HINS  $\overline{\text{PMG}}$

June 2<sup>nd</sup>, 2006

# Agenda

# Reactions to AAC Meeting

# Beam Diagnostic Elements

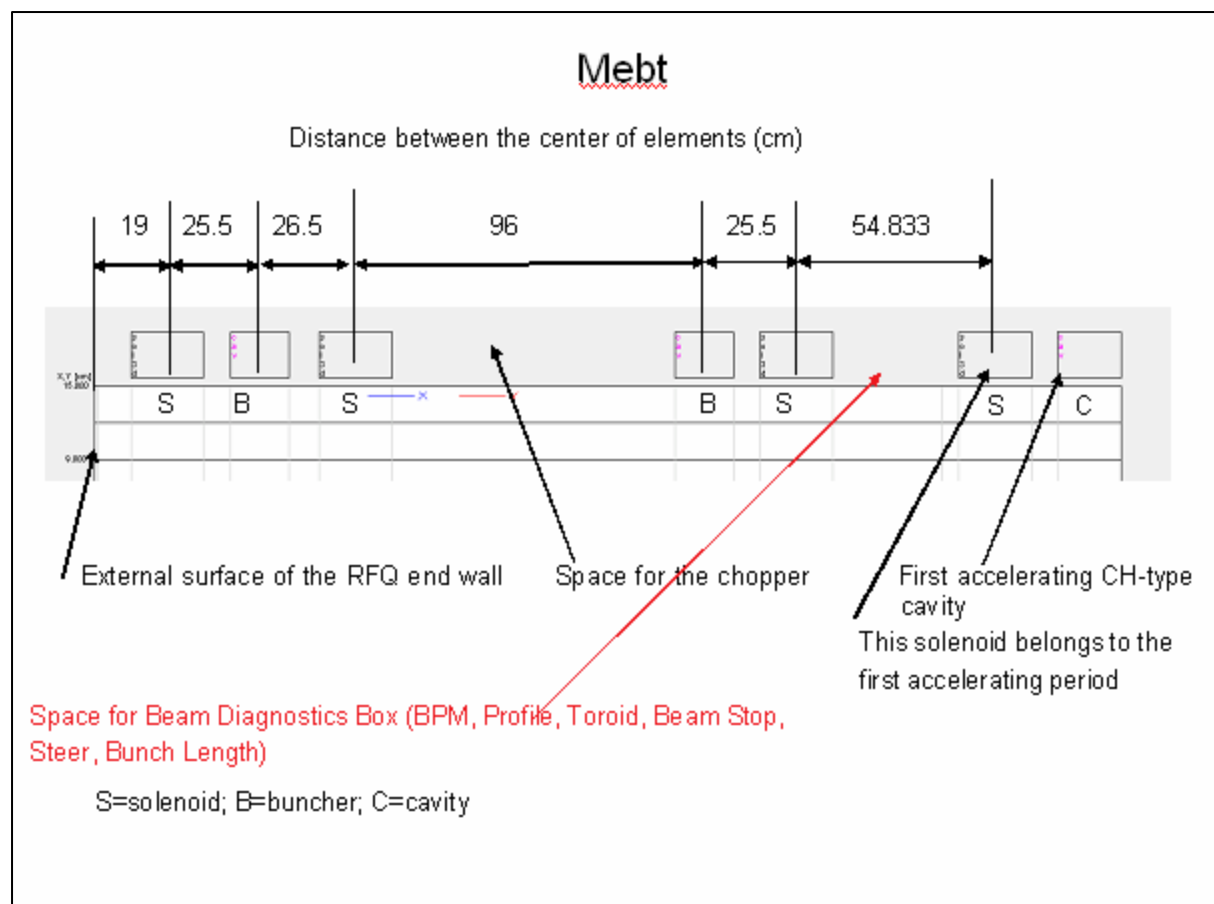
We are missing beam diagnostic stations in the layout!!! If the tunnel is too short, skip one SSR2 module but add beam diagnostics.

- Agreed:
  - Especially true for SSR1 & SSR2
  - FNAL “entrance” into new field
- Yes.
  - Agrees with our strategy in terms of
    - Schedule Risk
    - Cost Risk

- Activities:
  - Definition of Beam Diagnostic Elements
  - Allocation of Beam Diagnostic along Beam Line (P.O.)

- *Current transformers (CT)*: RFQ exit, MEBT exit, RT exit , between the cryostats, end of the linac
- *Beam phase pick-up*: after RT section, between the cryostats and at the end of linac
- Initial tune-up of the cavity field and phase
  - *360 deg slow phase shifter* in the ~Integral Design of RF Cavities ironically controllable
  - Use *RT and SC cavities as a phase pick-up* BNL MOU
- *Beam profile wire scanners* (or/and *laser scanners*)
  - MEBT – at least 1 scanner, 4 scanners after RT cavities, at least 2 scanners at the end of linac
- *Beam loss monitors* – about 20 – distribute along the linac

# Spoke Cavities Orientation

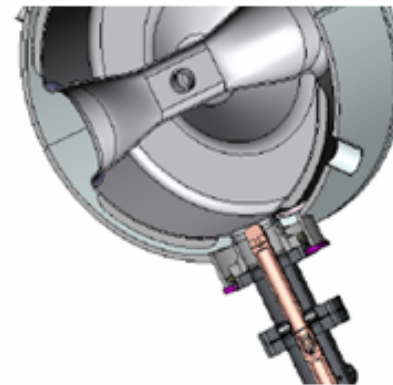
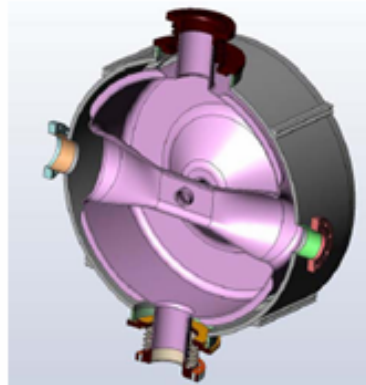
Caveat: The SSR uses the same orientation of spokes and input couplers. This arrangement may / will create some asymmetric field. The strength of this asymmetric field should be assessed and its impact to the beam should be studied

# Spoke Cavity Slow Tuner

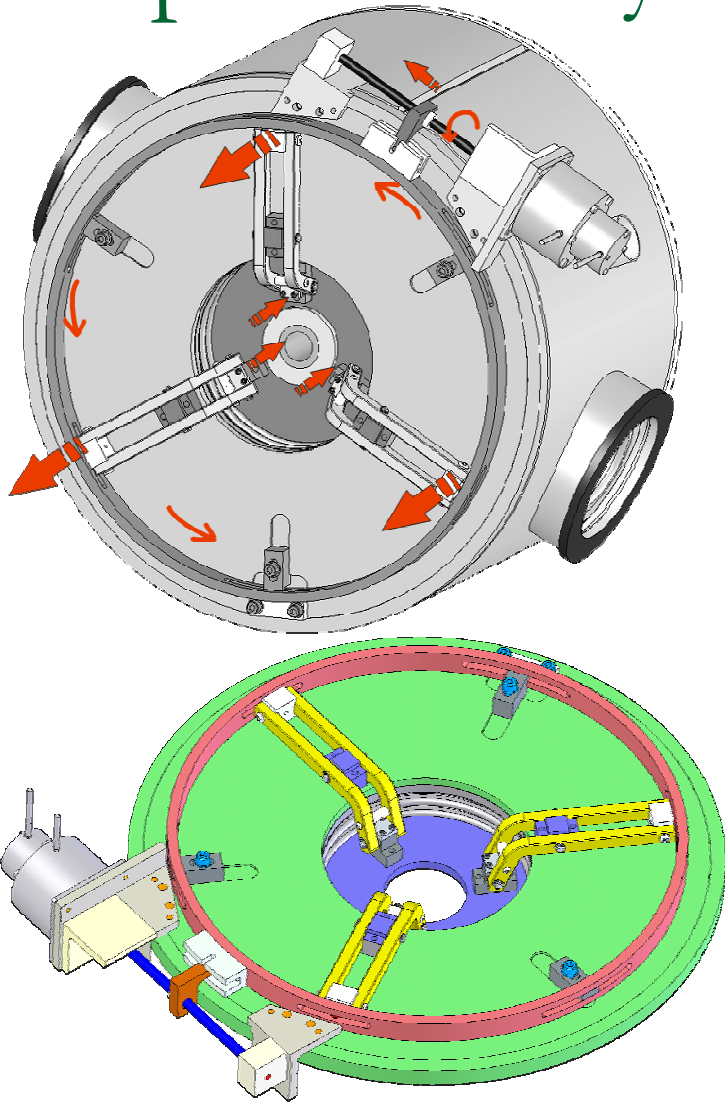
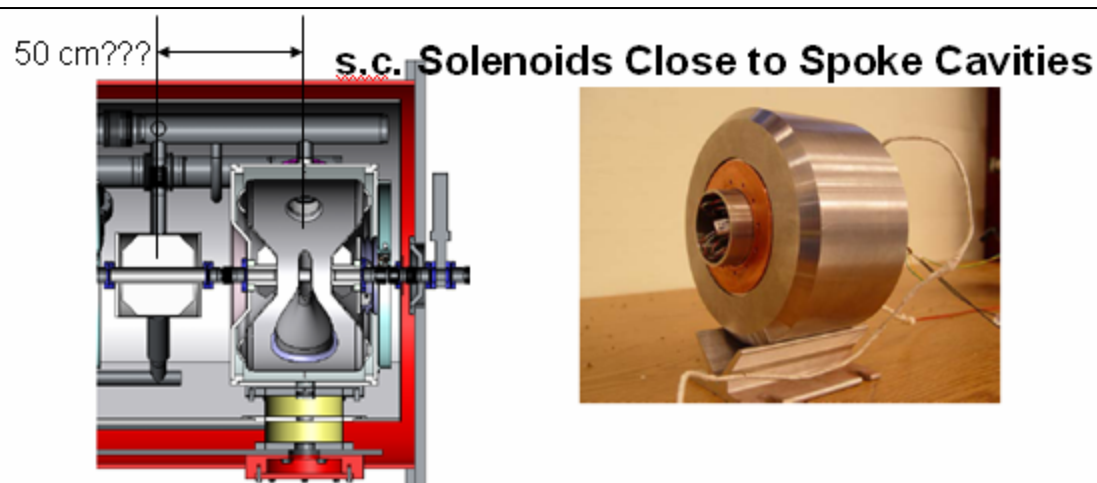
The tuner for SSR cavities uses stepping motors and gears, which are located inside the cryostat. Such systems are in operation for other SC accelerators.

Nevertheless, the whole tuner system (motor / gear system) should be tested for its function and long term reliability. This could be done before attaching it to the cavity and 'burying' it inside the cryostat.

- Build Prototype during summer '06
- Assembly
  - tooling group @ IB2 (L.Elementi)
  - Time: 1 week
- Testing
  - Test & Instrumentation Dept. (R.Carcagno)
  - Meeting scheduled on Jun 6 to define competencies and requirements
  - Time:
    - Short period testing @ 4K
    - At least 1 month (if it works...) @ LN2 T
  - Where: stand 3 @ IB1
  - When: likely October
